**GE Hitachi Nuclear Energy**

MFN 09-286

Subject: **Response to Portion of NRC Request for Additional Information Letter No. 301 Related to ESBWR Design Certification Application ESBWR RAI Numbers 22.5-22, S01, 22.5-24 S01 and 22.5-30 through 22.5-46**

**Regulatory Treatment of Non-Safety Systems (RTNSS)**

Figure 2.6.2-1. Fuel and Auxiliary Pools Cooling Cleanup System

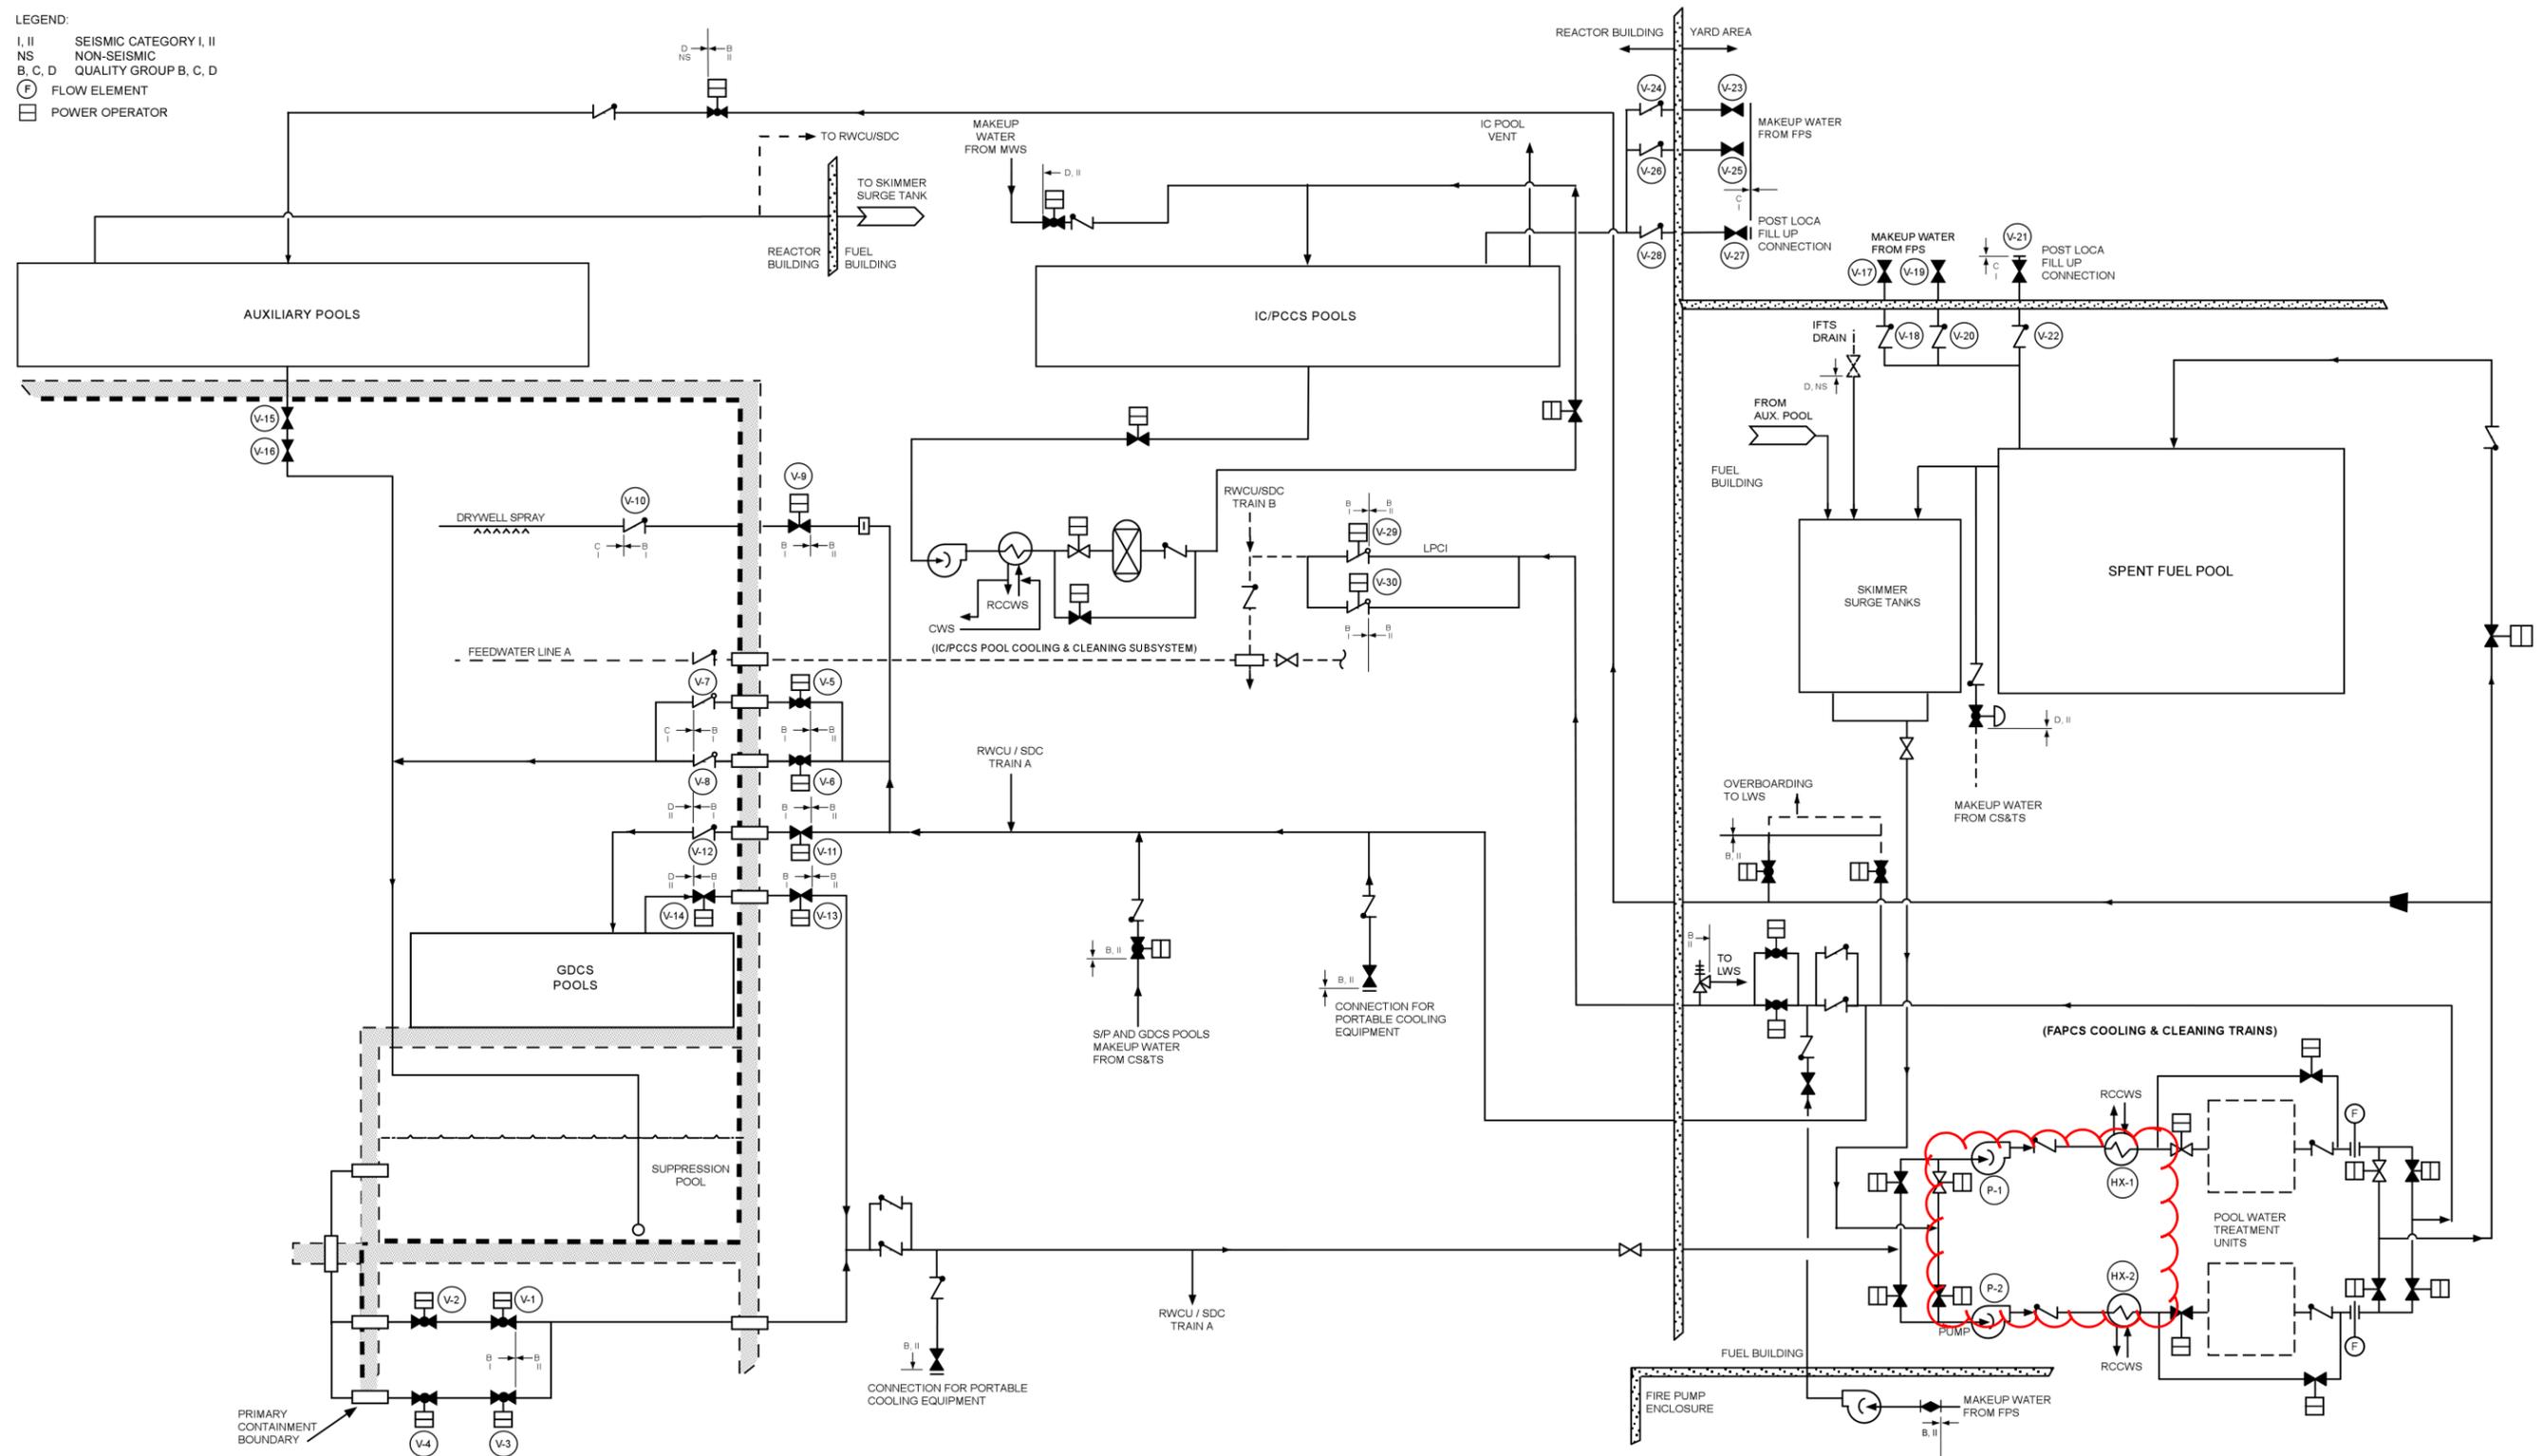
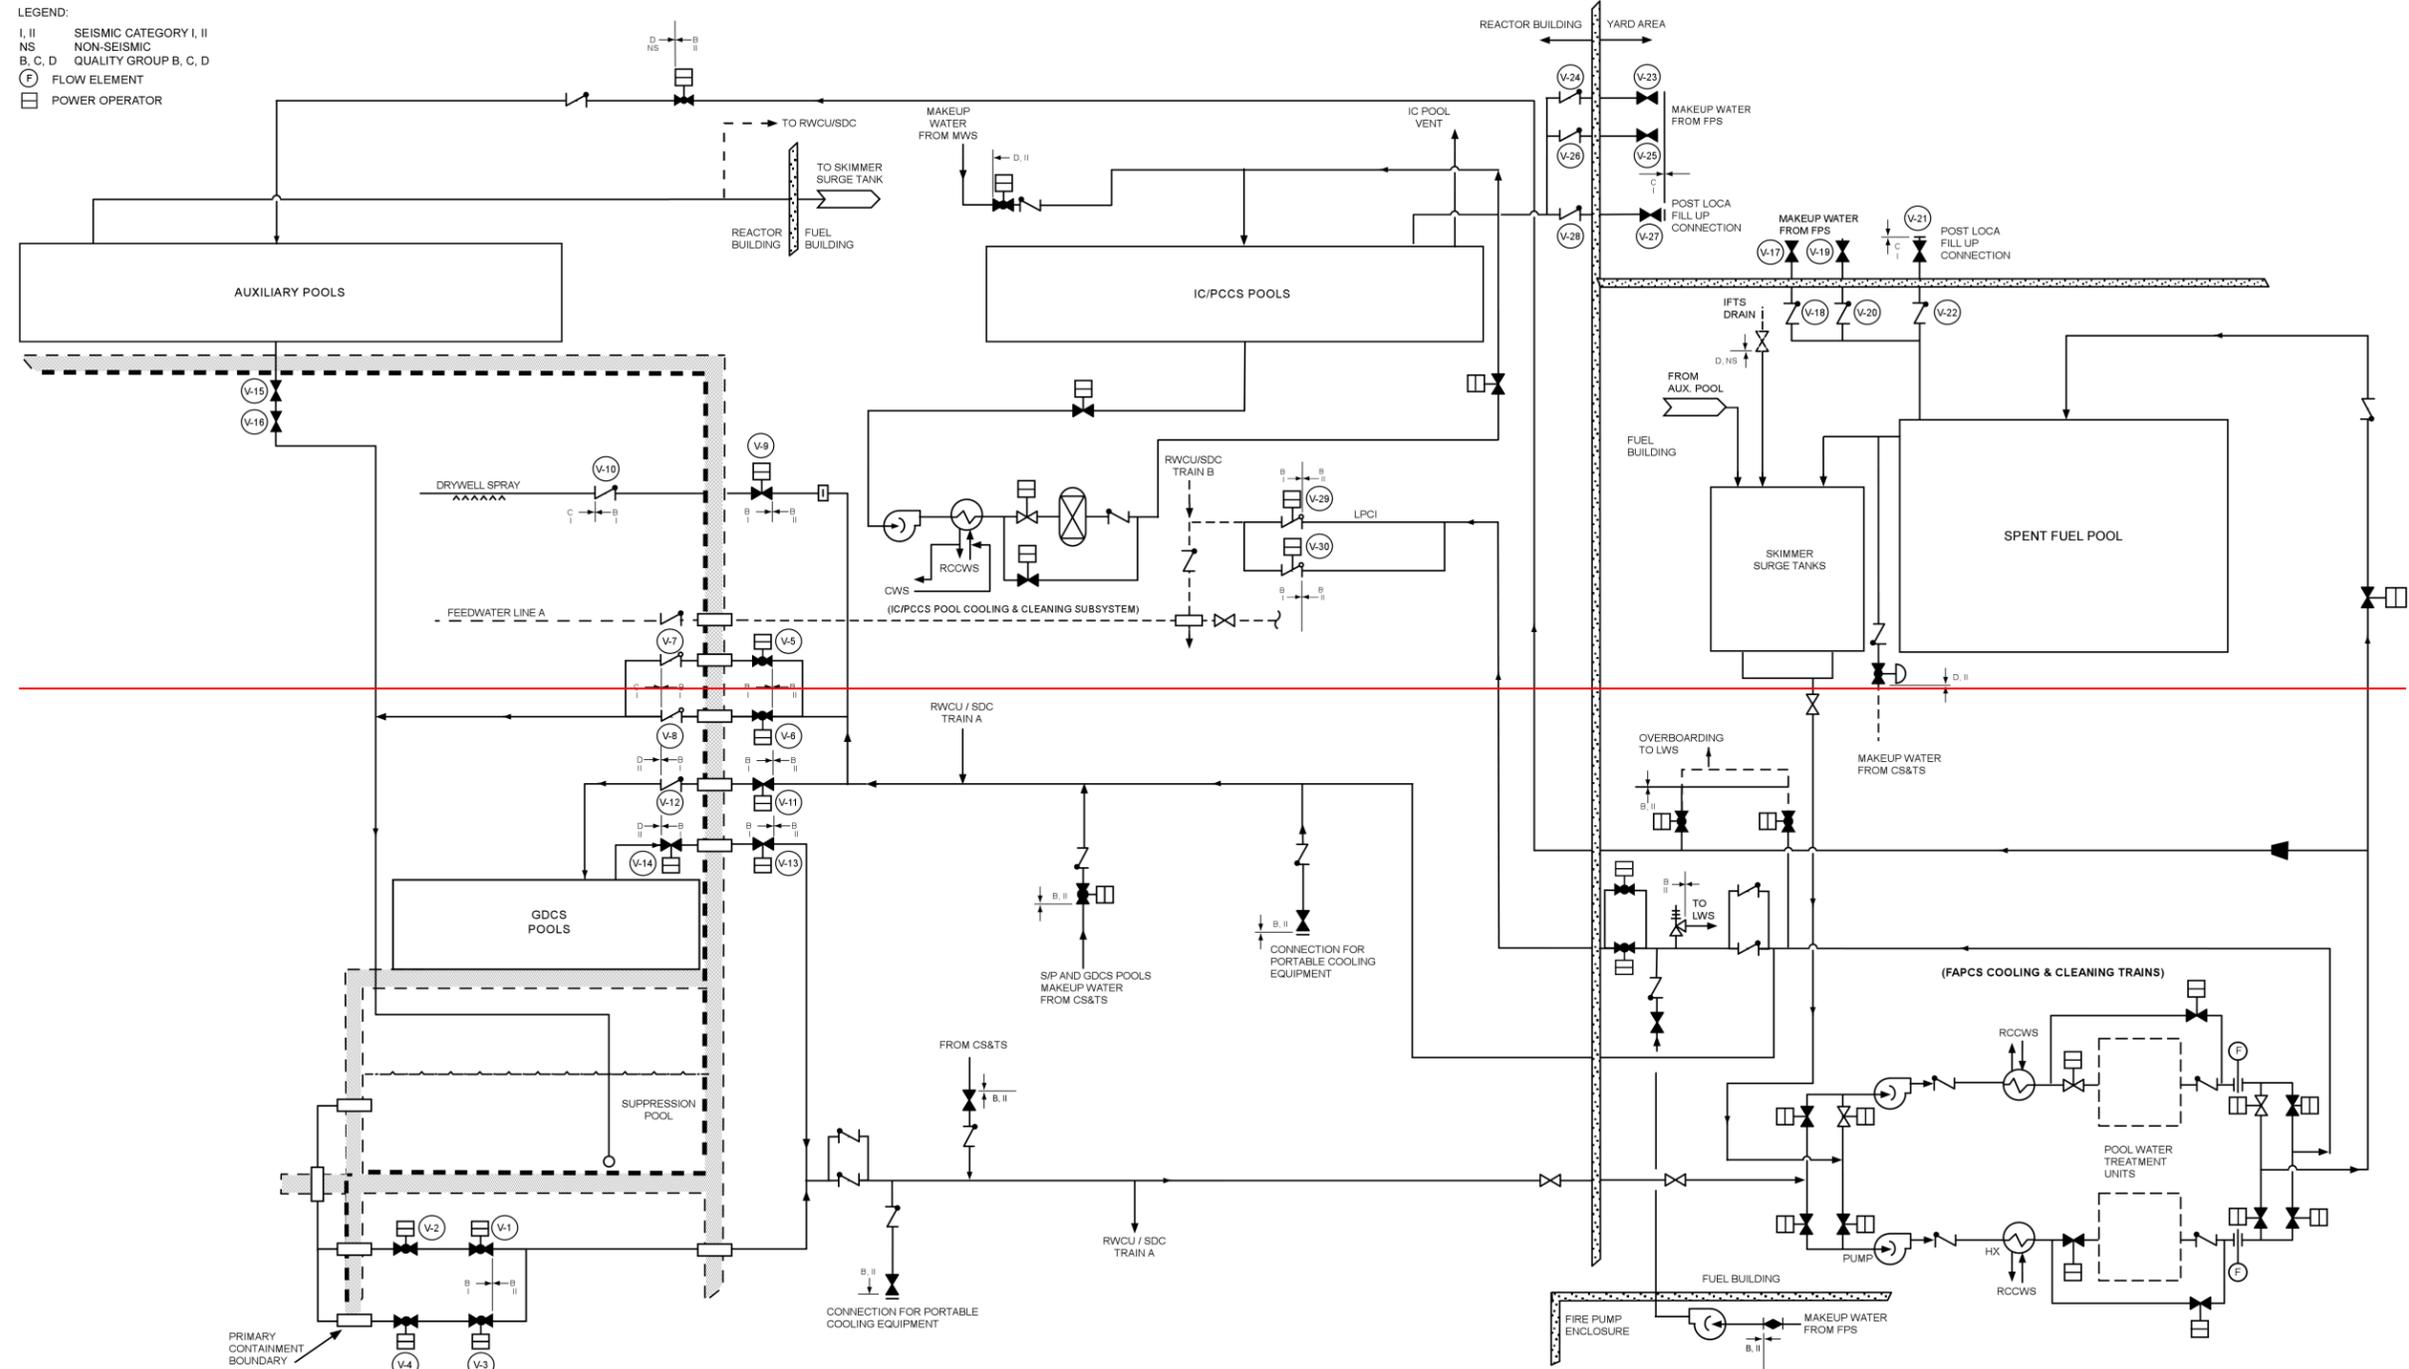
GEH will revise Table 2.6.2-1 to include the FAPCS pumps in the list of mechanical components.

DCD Tier #1, Table 2.6.2-1 and Figure 2.6.2-1 will be revised in Revision 6 as noted in the attached markup.
